January 6, 2000
1940-99-20662

Subject: Oyster Creek Nuclear Generating Station
Facility License No. DPR-16
Docket No. 50-219
Response to Request for Additional Information re:
Proposed License Amendment for Spent Fuel Pool Expansion

Enclosure 1

Two Dimensional Array of N Bodies (N=13)

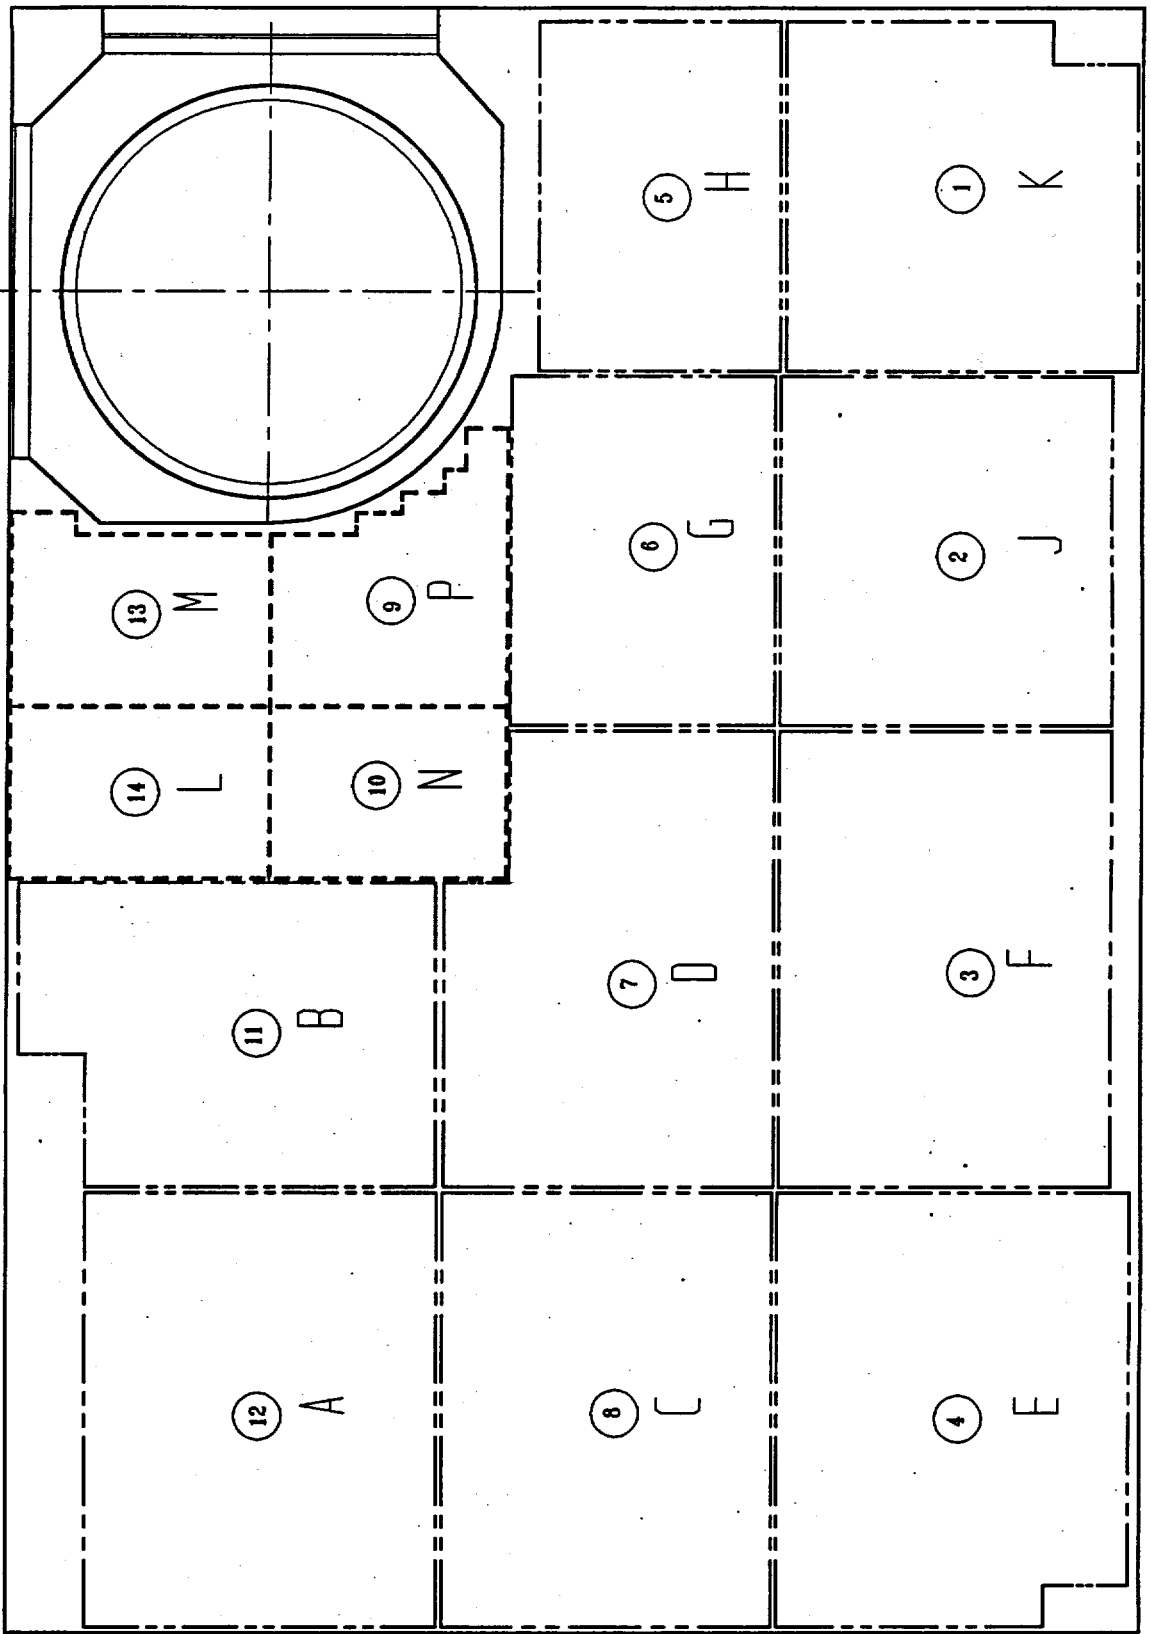
- (b) Provide the results of any prototype experimental study that verifies the correct or adequate simulation of the fluid coupling utilized in the numerical analyses for the fuel assemblies, racks and walls. If no such experimental study is available, explain how the current level of DYNARACK code verification is adequate for engineering application without further experimental verification work.

A key ingredient in the Whole Pool Multi-Rack (WPMR) analysis is quantification of the hydrodynamic coupling effect that couples the motion of every rack with every other rack in the pool. In 1987, Dr. Burton Paul (Professor Emeritus, University of Pennsylvania) developed a fluid mechanics formulation using Kelvin's recirculation theorem which provided the fluid coupling matrix ($2n \times 2n$ for a pool containing n racks). For example, with reference to Attachment 1.1, where an array of N ($N = 13$) two-dimensional bodies (each with two degrees of freedom) is illustrated, the dynamic equilibrium of the i -th mass in the x -direction can be written as:

**OCNGS Spent Fuel Pool Rack Layout
W/Gap Dimensions**

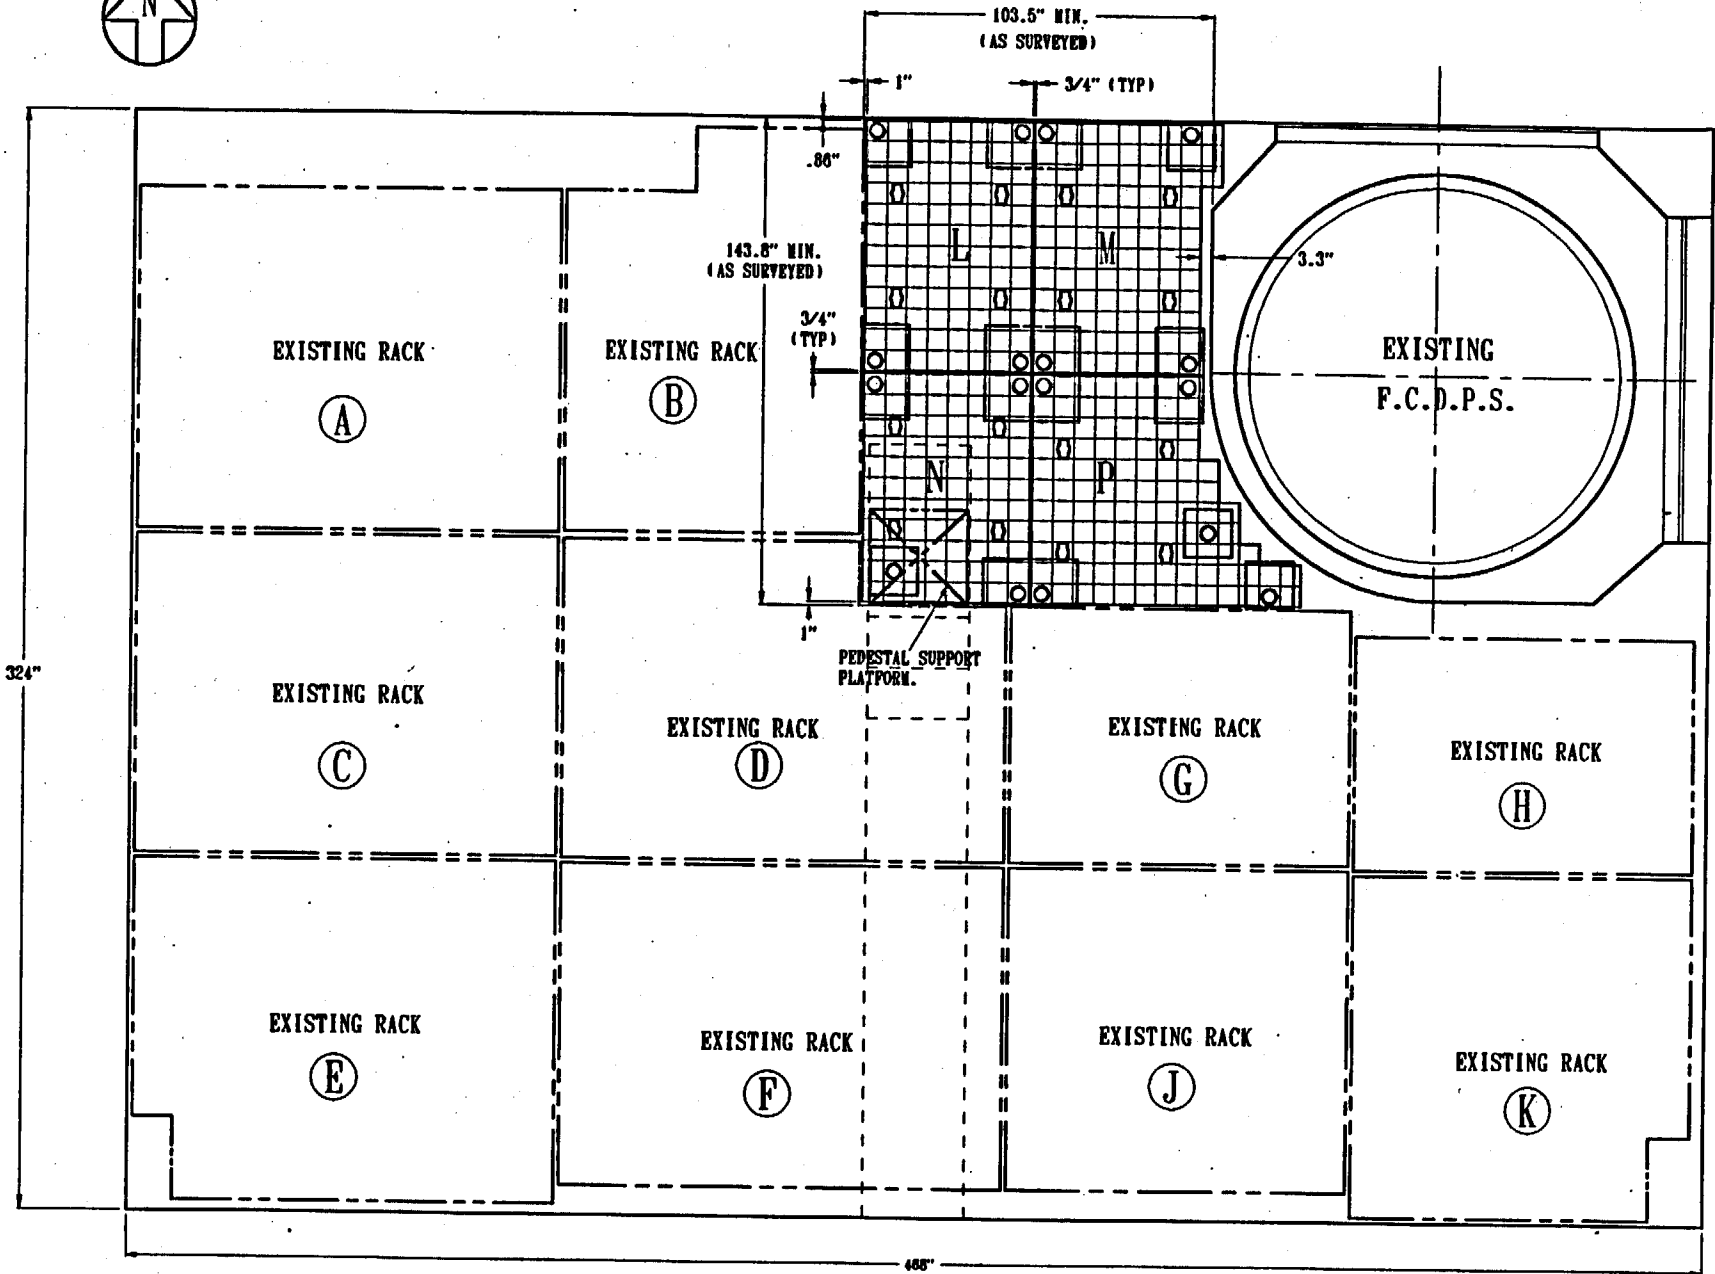
- (c) Provide the physical dimensions of the racks, and the gaps between the racks and the gaps between the racks and the spent fuel pool (SFP) walls.
- (d) Demonstrate that the artificial seismic ground motion time histories used in the analyses satisfy the power spectral density (PSD) requirement of SRP 3.7.1.

Attachment 1.2 shows the gaps between the racks and the gaps between the racks and the spent fuel pool (SFP) walls.
